ECP₁ DATE Jan. 2nd 2018 **ITEMS IMPACTED** V1Rx: BOM **BLOCKS IMPACTED** B5, B5B1, B5B2, B5B3, B5B4, B5B5, B5B6, B5B7 +15Vd **CHANGES** TLV1701 Change R324 in B5 to 182K/1%; Change resistor values in B5B1, B5B2, B5B3, B5B4 +15Vd +3V3D B5B5, B5B6 & B5B7 as shown. **REASON** Possible change in driver control signal levels from 0-15V to 0-5V. **ACTION** +3V3D Use original component values for 0-15V driver control signals. +15Vd Use new values proposed herein for 0-5V driver control signals. W TLV1701 DRIVER DOWN 15V +15Vd +3V3D Oficina Técnica Universidad Carlos III de Madrid uc3m Sistema Emulador Planta Generación Eólica; Carrier E/S para placa MicroZed Engineering Change Proposals ECP1 CODIGO OT Size A4 OT-2017-4302 Sunday, December 02, 2018 Designed by Ernesto García Ares Checked by Approved by Sheet <Comprobado por> <Aprobado por> 41 of 41

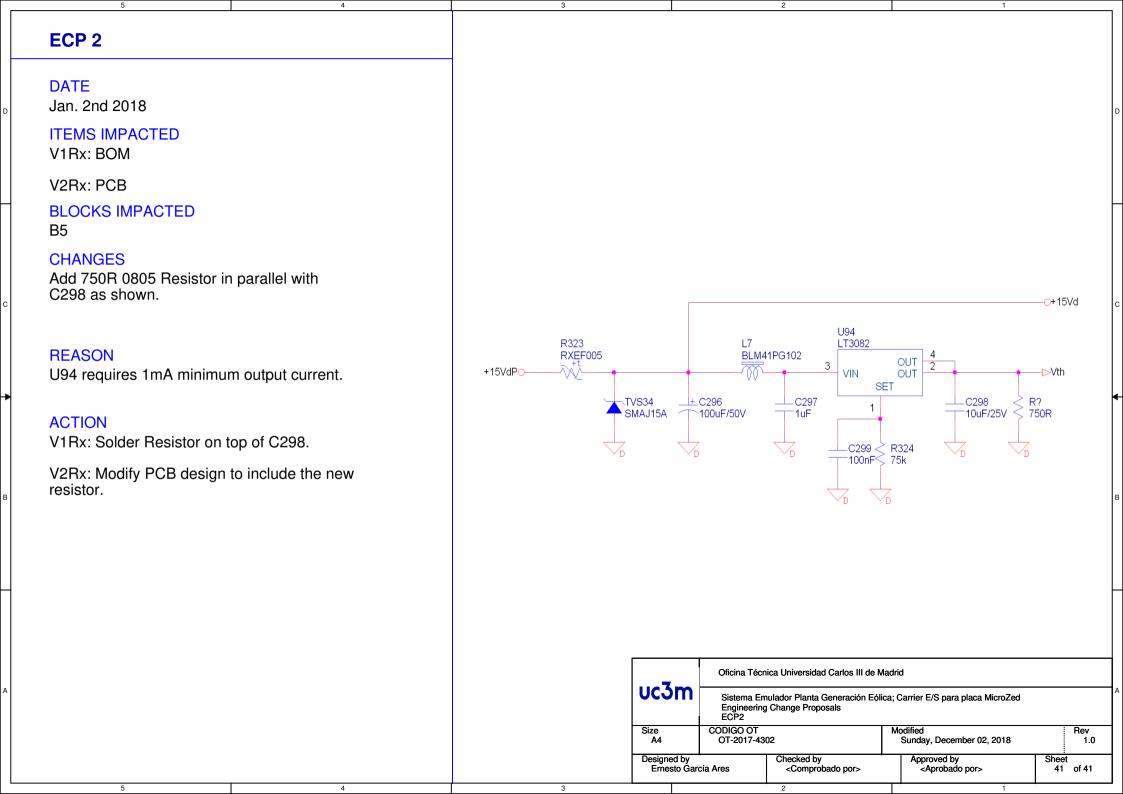
ECP 3 DATE Jan. 2nd 2018 **ITEMS IMPACTED** V2Rx: PCB **BLOCKS IMPACTED** B3B1, B3B2, B3B3, B3B4 **CHANGES** Modify footprint for U10, U12, U14, U24. **REASON** Easily available version is 220mil wide. 180 mil package is not readily available. **ACTION** V1Rx: Bend pins inwaard to fit 180mil footprint. V2Rx: Modify PCB design to include 220 mil footprint Oficina Técnica Universidad Carlos III de Madrid uc3m Sistema Emulador Planta Generación Eólica; Carrier E/S para placa MicroZed Engineering Change Proposals ECP3 CODIGO OT Size A4 OT-2017-4302 Sunday, December 02, 2018 Designed by Ernesto García Ares Checked by Approved by Sheet <Comprobado por> <Aprobado por> 41 of 41
